STATE OF  
COLORADO

## Adequacy-Review Response on TR-10 / Cross Gold Mine / M1977-410

**Phone:** 720-893-3749**Mobile:** 516 582-0833**Email:** [Rmittasch@nedmining.com](mailto:Rmittasch@nedmining.com)[4415 Caribou Rd](#), PO Box 3395, Nederland, CO 80466**M1977-410\_TR-10\_Adequacy-Review (response ver6)\_20Apr22 (final) .pdf**

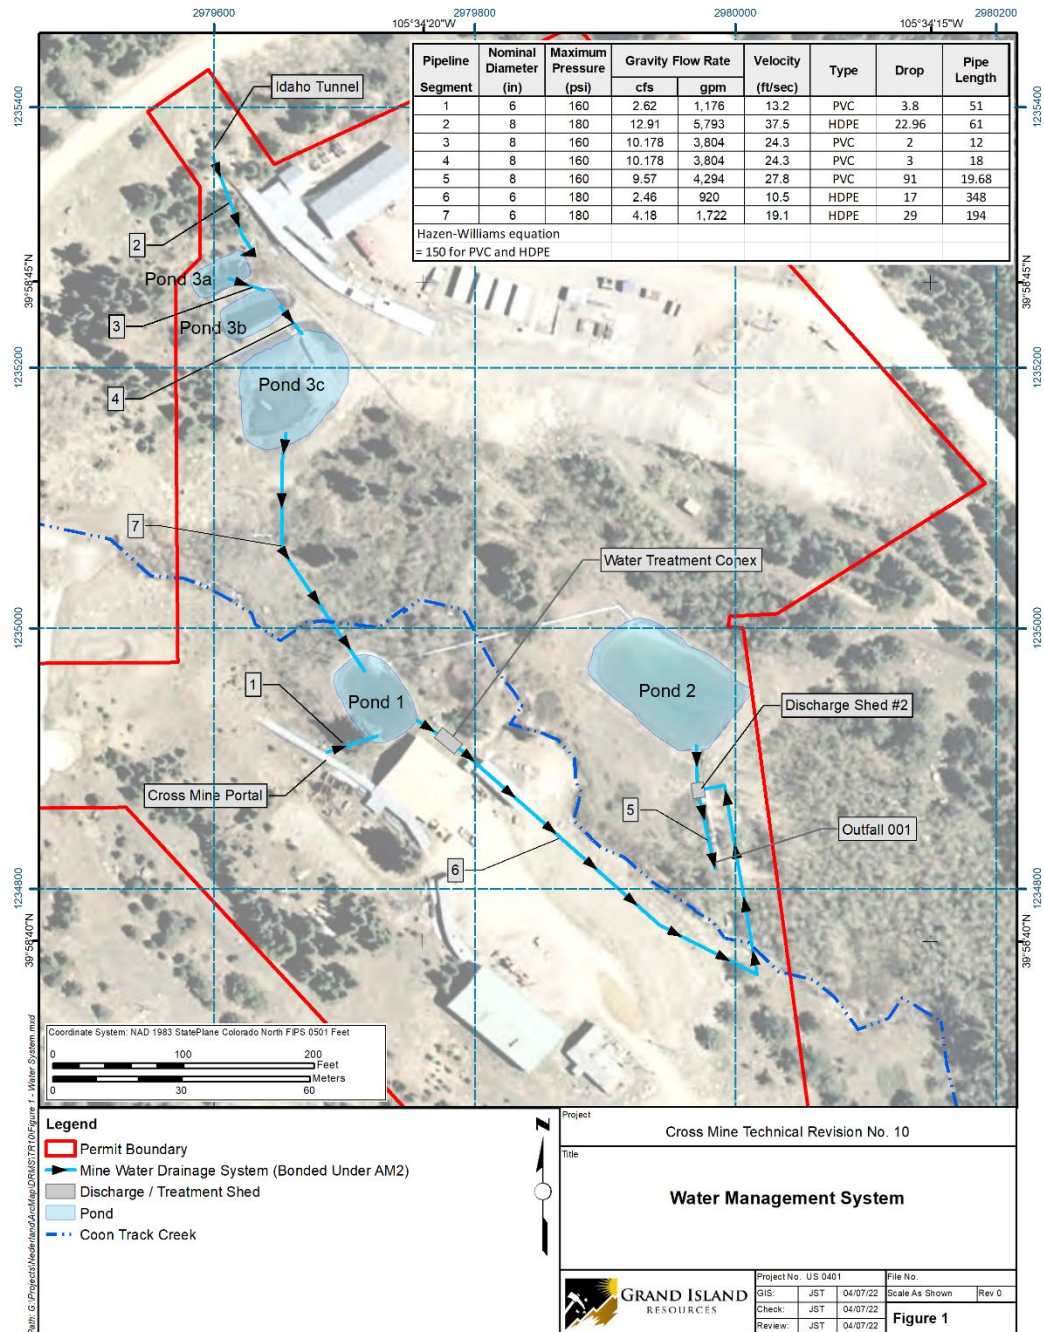
**DRMS Comments 3a-3d:** The Division has the following comments pertaining to Figure 1 – Water Management System:

- a. Please add the approved permit boundary (at least the portions visible in the view shown).
- b. Please show the location of the permitted outfall on Coon Track Creek.
- c. Please include arrows on the pipelines indicating the flow direction.

- d. Please differentiate the pipelines recently installed to support the new water treatment system.

**DRMS Comment 13:** The bond estimate calculated for Amendment No. 2 (AM-2; approved on February 8, 2022) includes costs for removing and disposing of a total of 777 feet of 6-inch diameter pipeline. According to Figure 1 – Water Management System, a total of 1,585.68 feet of pipeline is installed at the site, including a combination of 6-inch diameter and 8-inch diameter PVC and HDPE pipeline. Please provide a bond estimate that includes costs for removing and disposing of the additional 808.68 feet of pipeline.

**GIR Comment 3a-3d Response:** *Please see revised map below:*

**GIR Comment 13 Response:** *The prior Figure 1 was labeled incorrectly as all piping was included in the approved AM2. Figure 1 has been revised accordingly.*

*Figure 14 depicting isolation valve and backwash tank. Water in tank is emptied into Pond 1 for retreatment. Recently, this tank has been replaced with direct piping to Pond 1 for retreatment during a vessel backwash.*

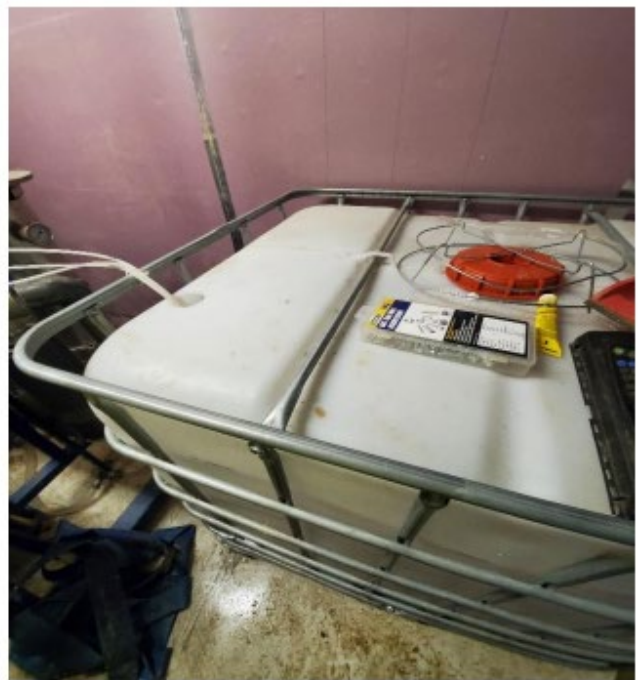
**DRMS Comment 11:** In Appendix A – Site Pictures, Figure 14 shows a photo of the “backwash tank” located inside the new water treatment shed. Please provide some additional information on the purpose of this tank, the nature of the water present inside the tank, whether the tank must be emptied regularly, and if so, where the water is poured.

**GIR Comment 11 Response:** *See Figure description modified below:*

Figure 1: Outfall 001 and Surface Water Sampling Locations, which shows property ownership and permit boundaries.

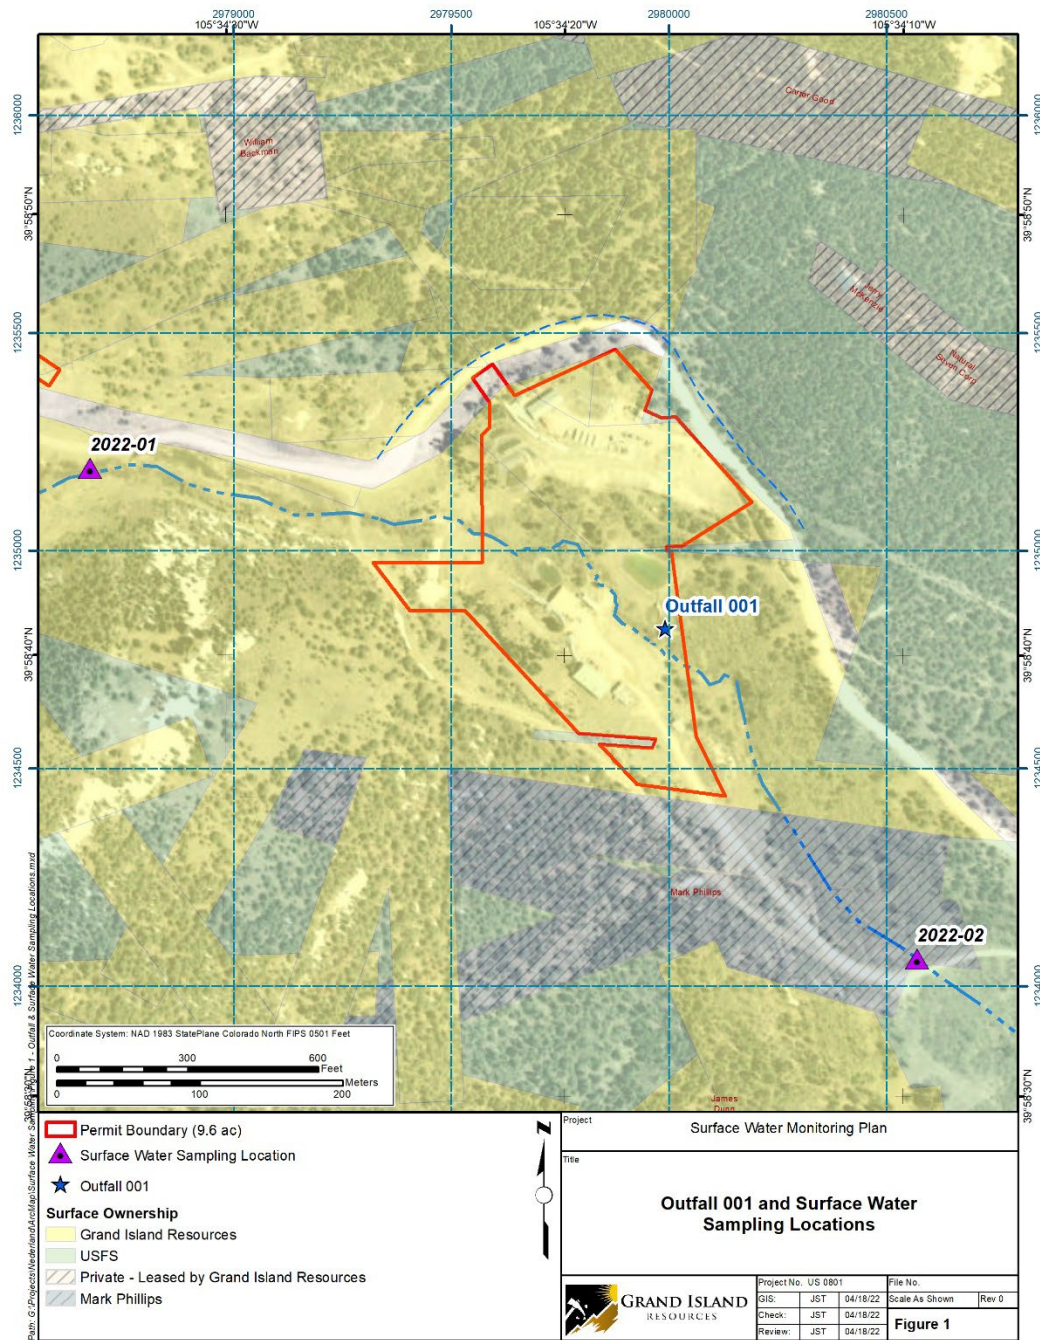
**DRMS Comment 15:** A groundwater monitoring plan is included in Appendix H. However, the Division could not find a surface water monitoring plan as required by corrective action #1 of the Board Order issued for Violation No. MV-2021-017. Please modify the monitoring plan provided to include both a groundwater and surface water monitoring plan. The surface water monitoring plan must include at a minimum, sampling locations along Coon Track Creek at a point upgradient of the mine site, at the discharge point, and at a point downgradient of the mine site. The list of surface water sampling parameters must include, at a minimum, the parameters required under the CDPHE discharge permit.

**GIR Comment 15 Response:** *The surface water monitoring program is attached as Attachment D.*

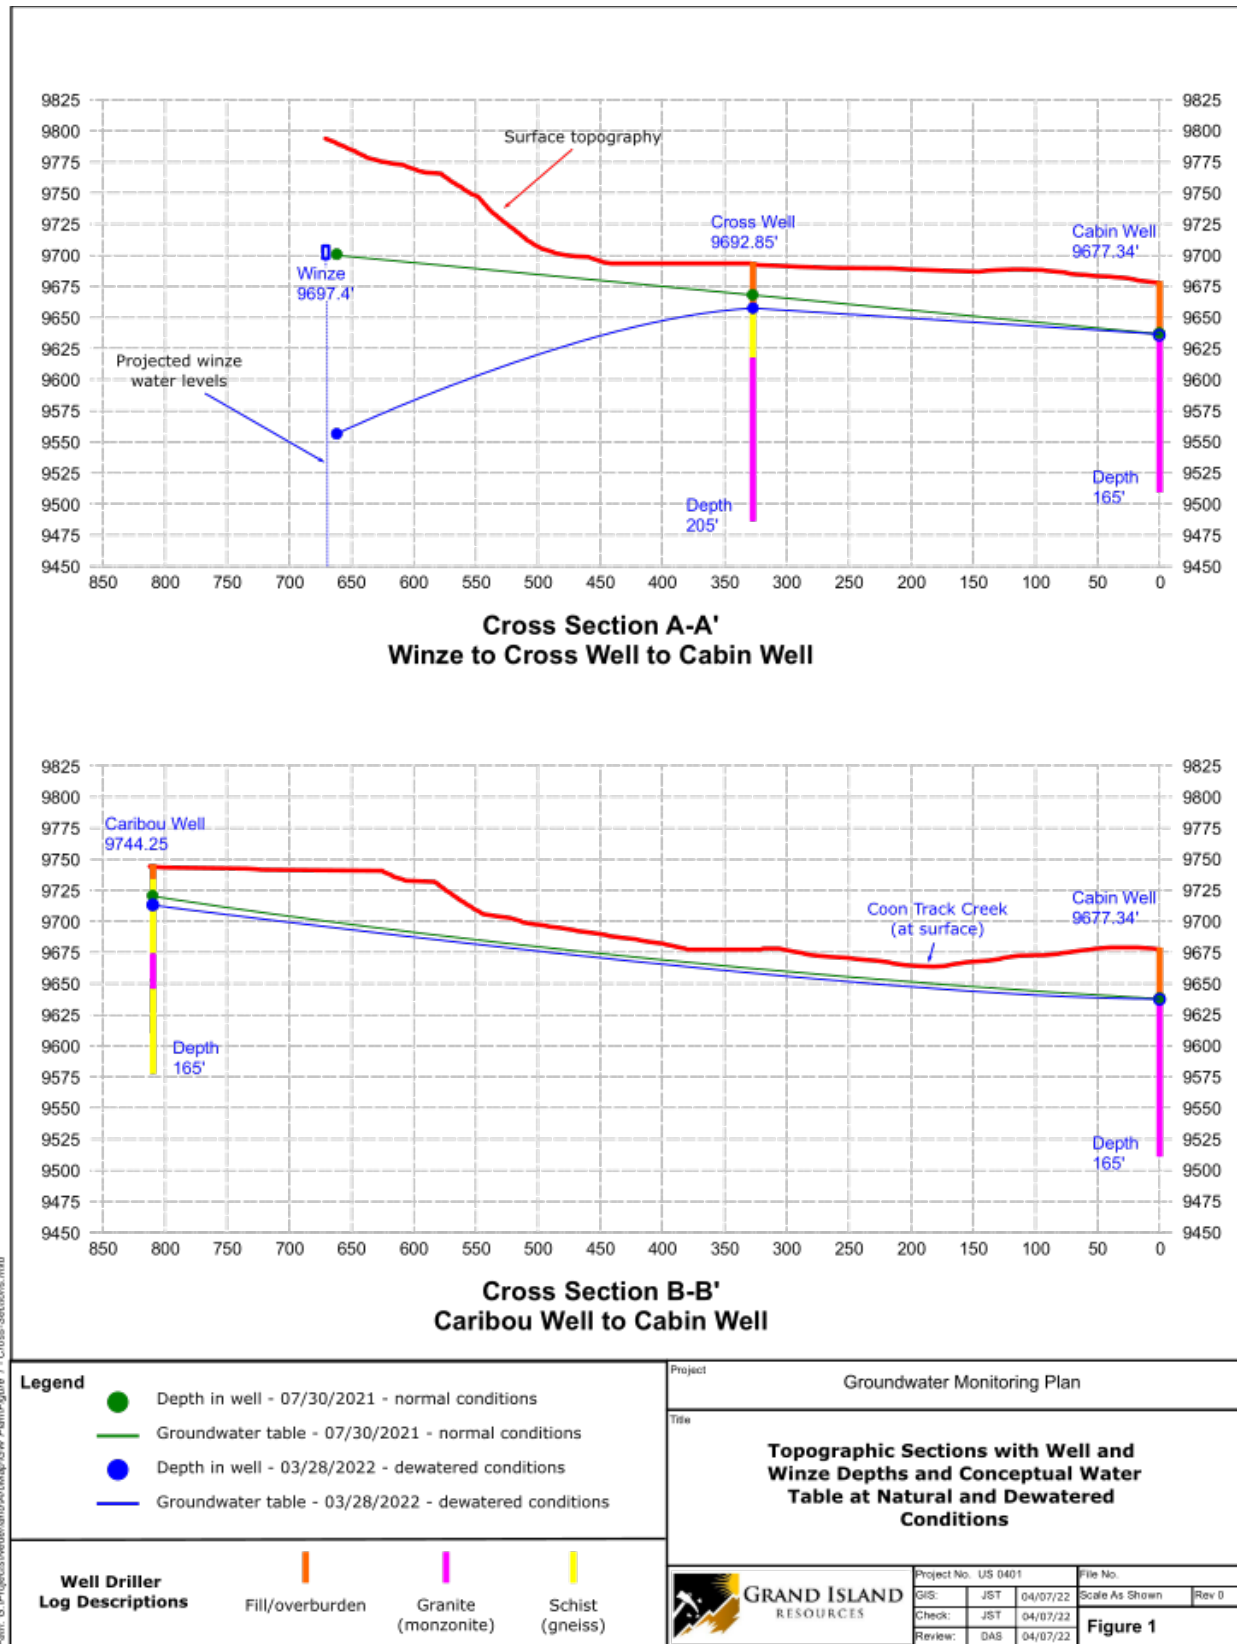
**DRMS Comment 25:** Please provide a generalized cross-section of the site which includes the approximate mine pool level of the Cross Mine (at both natural and dewatered conditions), groundwater levels in the Cross Well and Cabin Well, and shows the approximate location of any applicable surface features, including mine features and Coon Track Creek.

**DRMS Comment 26:** Please provide a generalized cross-section of the site which includes the approximate mine pool level of the Caribou Mine (at both natural and dewatered conditions), groundwater levels in the Caribou Well and Cabin Well, and shows the approximate location of any applicable surface features, including mine features and Coon Track Creek.

See below for multiple figures which clarify **DRMS Comments 25 and 26:**

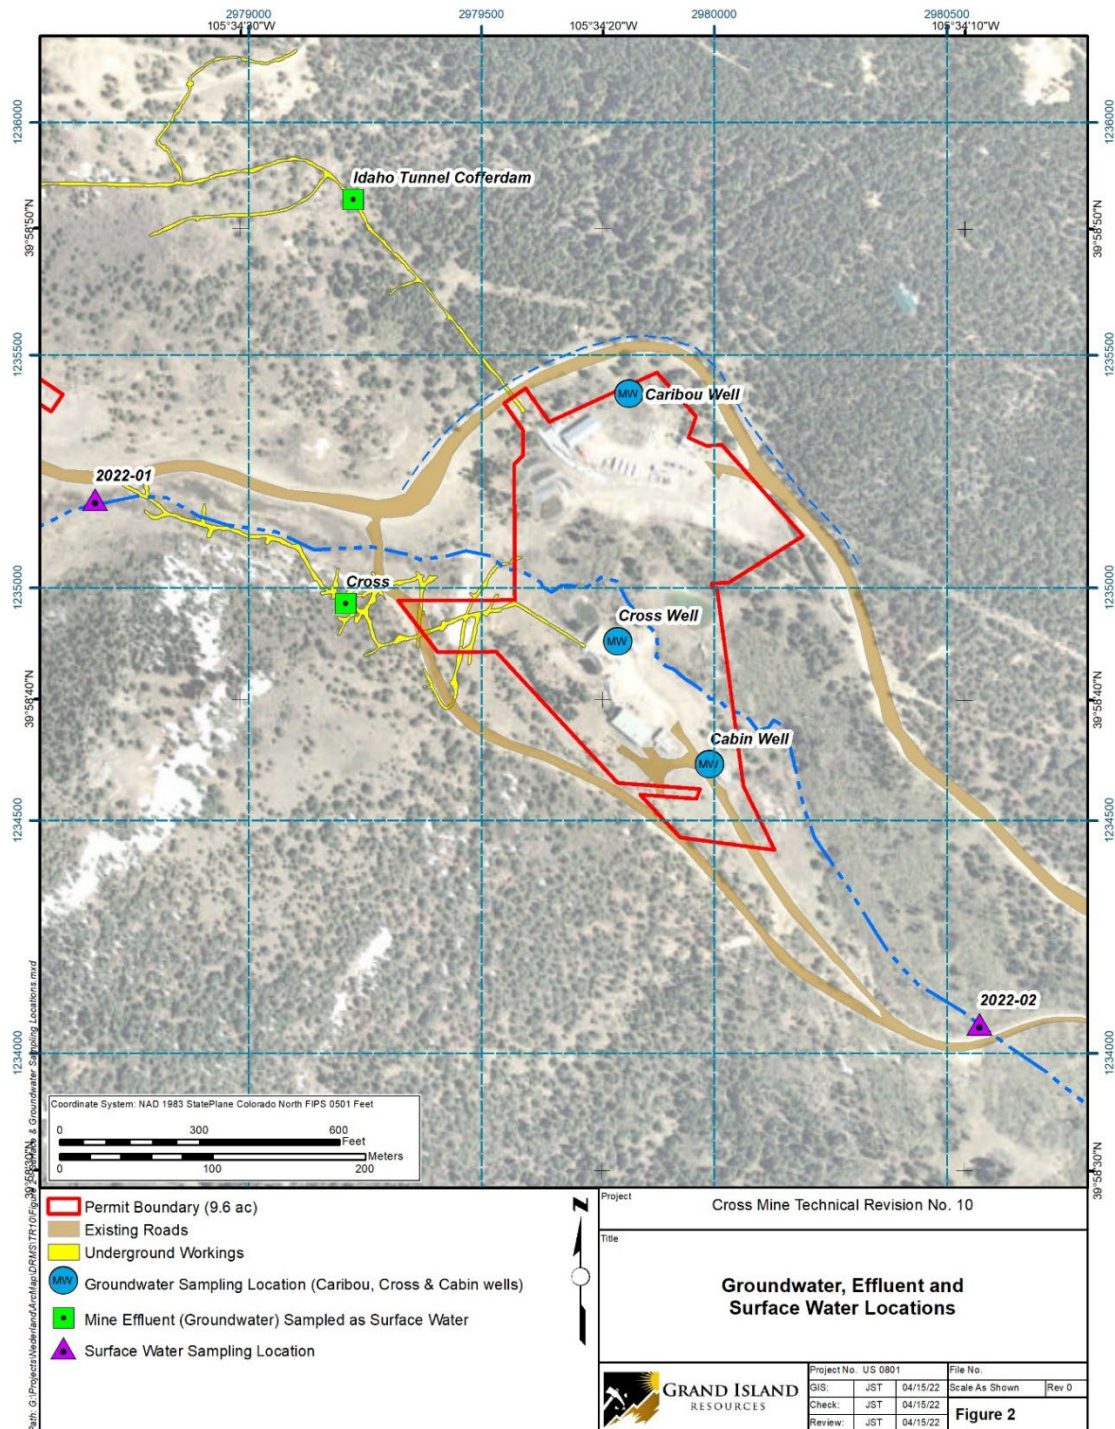
**DRMS Comments 27a-d:** The Division has the following comments regarding Map 2 – Site Map – Groundwater Monitoring Plan:

- a) Please change the map title to “Surface and Groundwater Monitoring Plan”.

**GIR Comment 27a and 27b Response:** *A new combination groundwater, surface water and effluent sampling map can be found in Attachment F.*

Clarifies **DRMS Comment 27b.**, see figure below:
